Item 5.**Development Application: 104 Pitt Street, Redfern - D/2023/1179**

File No.: D/2023/1179

Summary

Figure 12: Proposed ground floor plan

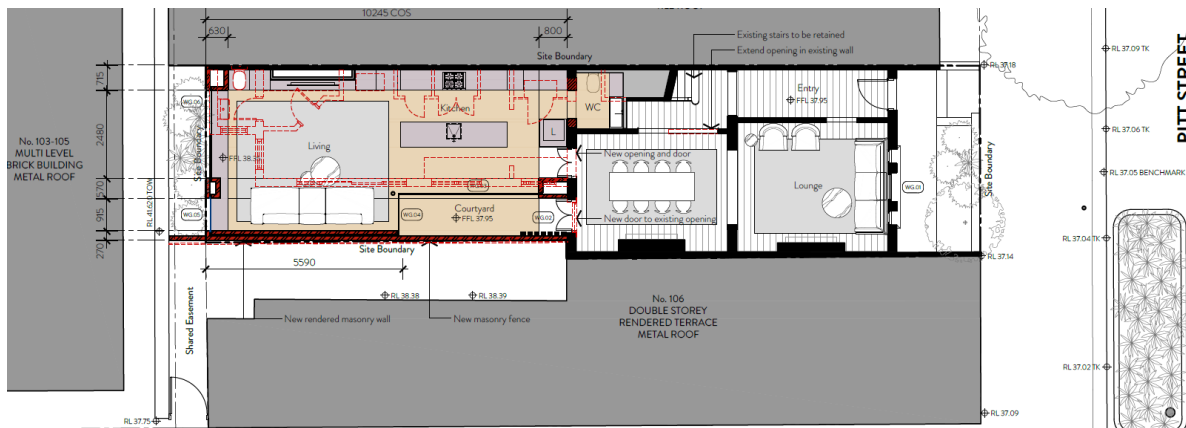
26. Therefore, a design change condition of consent is recommended that requires (a) the existing timber fence is untouched and maintained, (b) the proposed masonry southern boundary fence is deleted from the application and (c) that no structures or works is permitted within or over the easement / 98 Pitt Street Redfern.

27. Furthermore, the proposed western facade glazing at the ground level living includes floor to ceiling sliding doors (WG.06). This design is not compatible with the interface to the easement. Therefore, a design change conditions has been imposed that requires the ground floor western facade to comply with Volume 2 Part 3.7.2 Fire Separation of External Walls. This may require the glazing to be constructed to FRL 60/60/60, or redesigned to be masonry construction that is 90mm thick, or require a performance solution.

Figure 16: Proposed western elevation plan

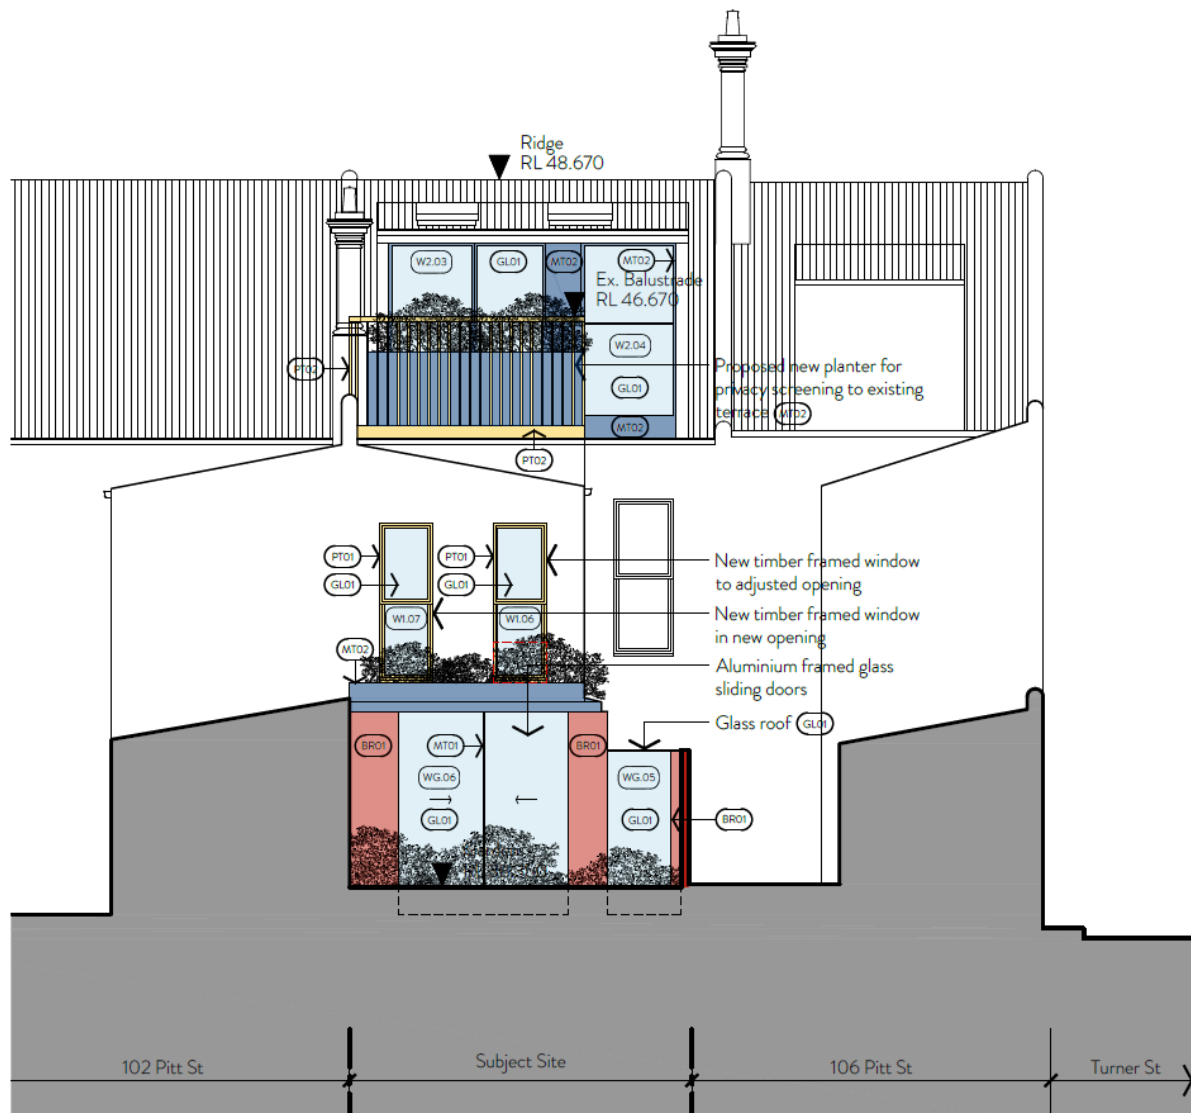
4.1.3.6 Visual privacy	Yes	<p>The proposed development does not introduce any new windows to the development aside from the Level 1 Bedroom 3 western façade windows which looks to the adjoining health care building. No adverse privacy impacts arise from this window.</p>

Figure 20: Survey Plan dated 2017 (source D/2022/783)

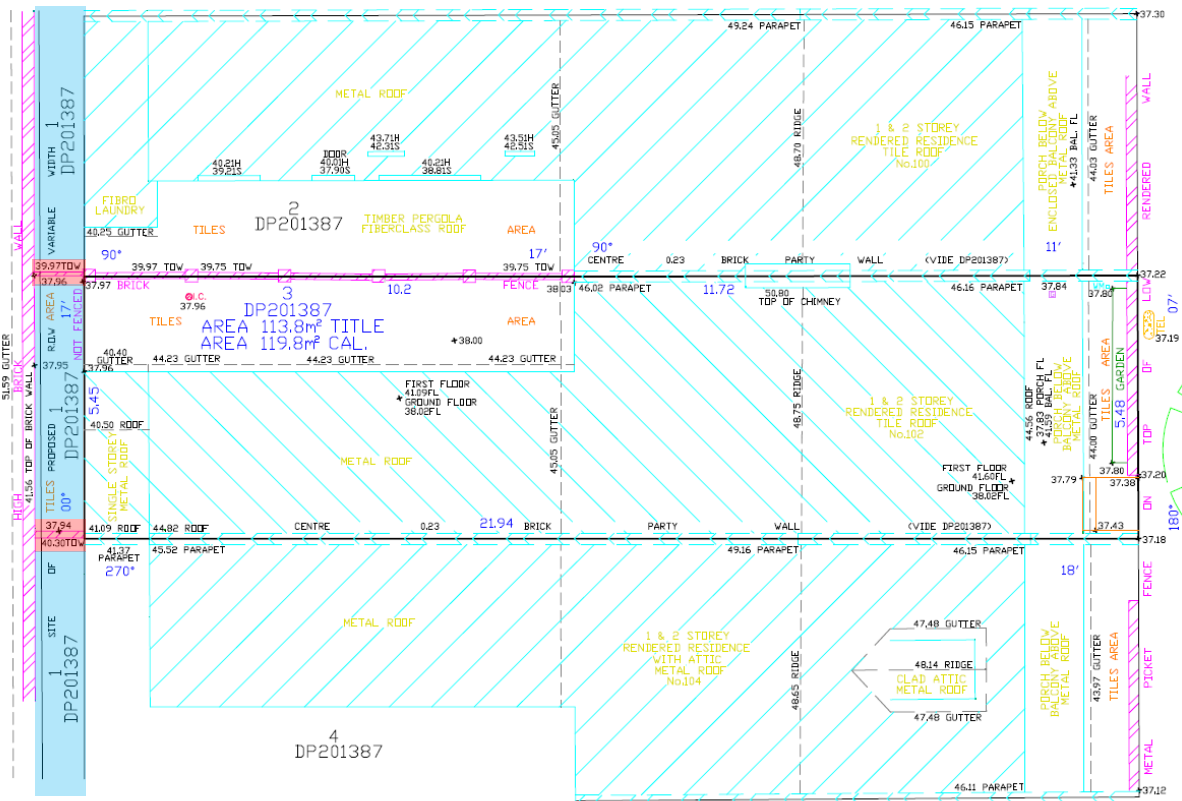
23. Based on a review of the adjoining sites and survey plans prepared between 2017 and 2023, it would appear that each neighbour has constructed over time, solid masonry walls which extend into this Right of Footway easement and essentially block north-south pedestrian access in the easement. It does not appear that any landowners consent from 98 Pitt Street Redfern has been obtained by these properties which have constructed the fencing.

24. The subject site has an existing timber panel fence which extends and blocks this easement as shown in the site photo provided below at **Figure 19**. As a result, each property (100, 102, 104 and 106 Pitt Street) have privatised the area of the Right of Footway easement despite the easement existing on title. Extract of a survey plan in Council's records dated 2017 is provided below at **Figure 20** - area of the easement is in the left-hand side of the extract with the easement shaded blue and the masonry walls prohibiting access are in red.

Figure 22: Floor plans for 106 Pitt Street Redfern (source: D/2006/1159)

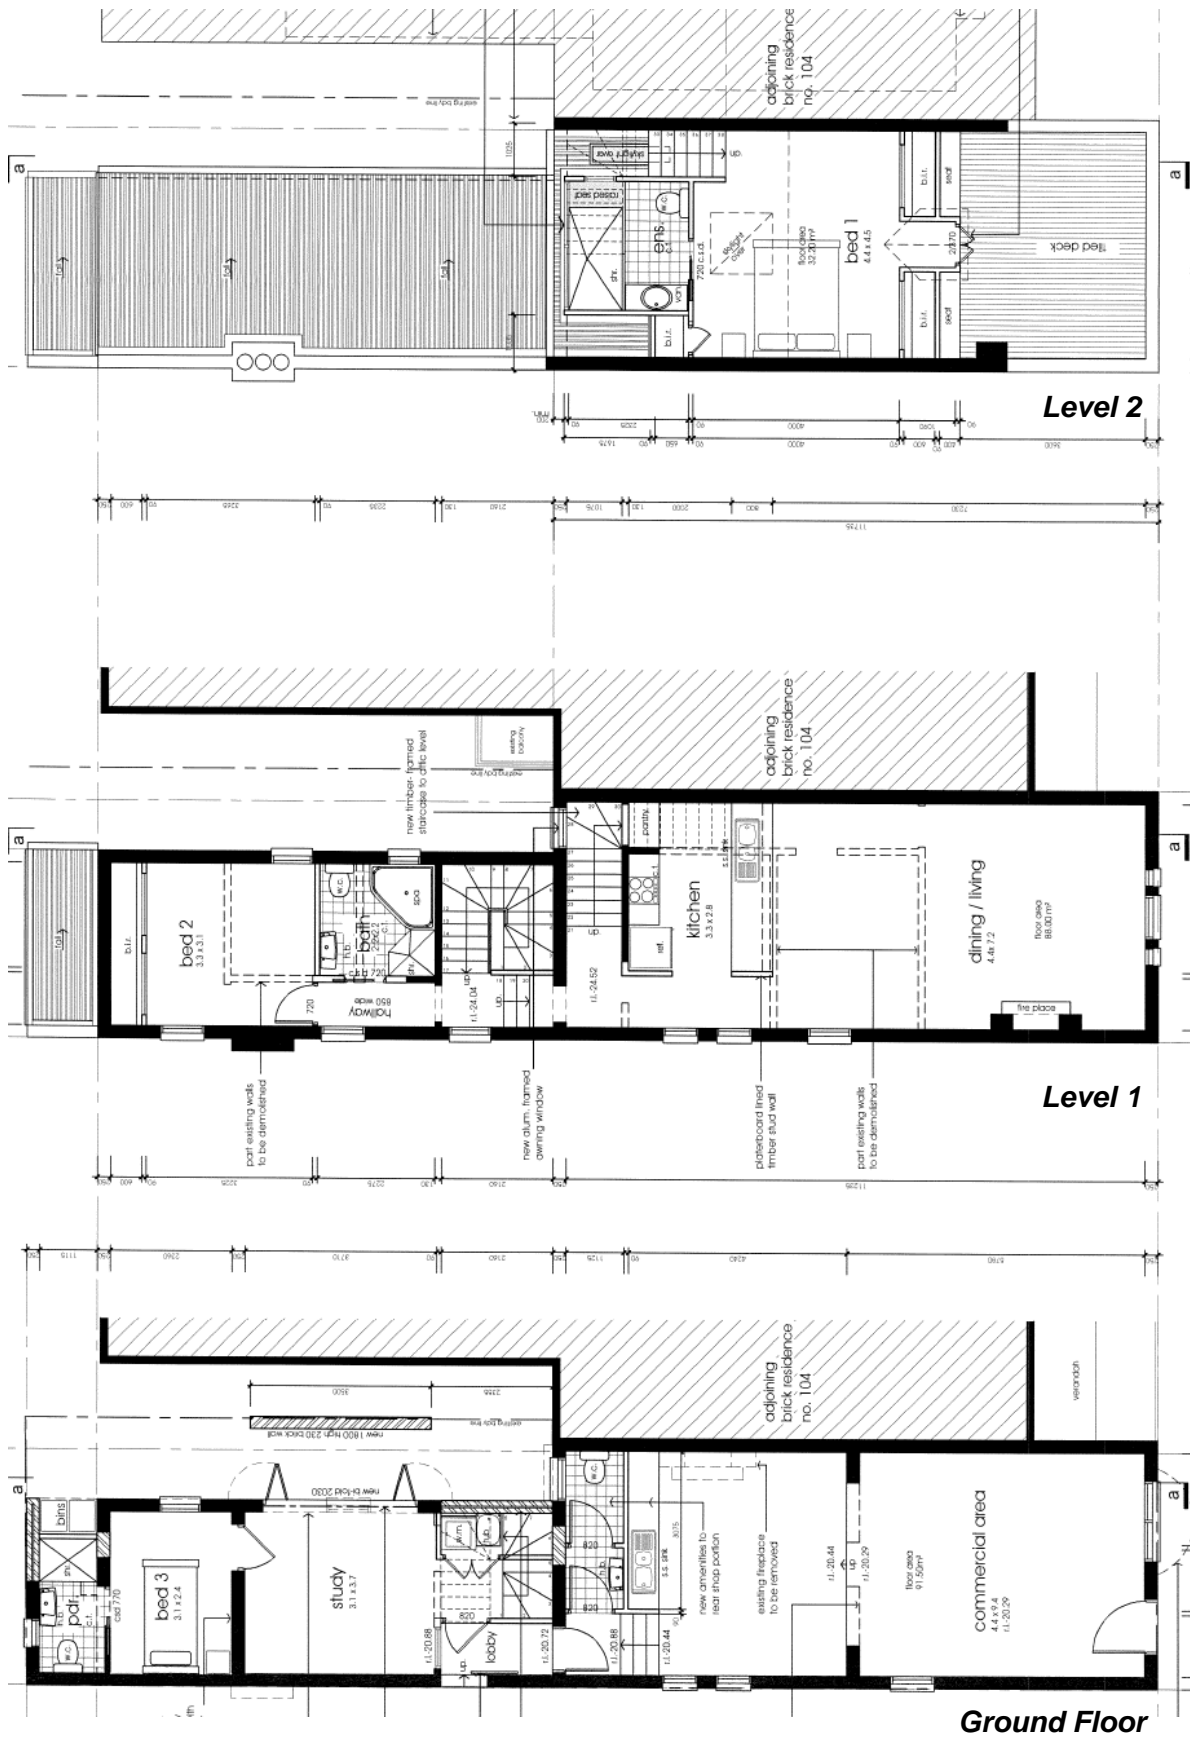
51. In relation to solar access to the southern adjoining neighbour at 106 Pitt Street, the POS is located at the ground floor and access via the bi-fold doors from the study and the living area is located at Level 1 fronting Pitt Street - refer to floor plan below for reference. The POS area is already overshadowed by the existing subject site dwelling and the living area receives unobstructed eastern sun during the morning period. As per provision 4.1.3.1 (2) new development must not create any additional overshadowing impacts where solar access is less than 2 hours and as the proposed development does not result in any greater overshadowing impacts to living areas and POS, the application is acceptable in this regard.
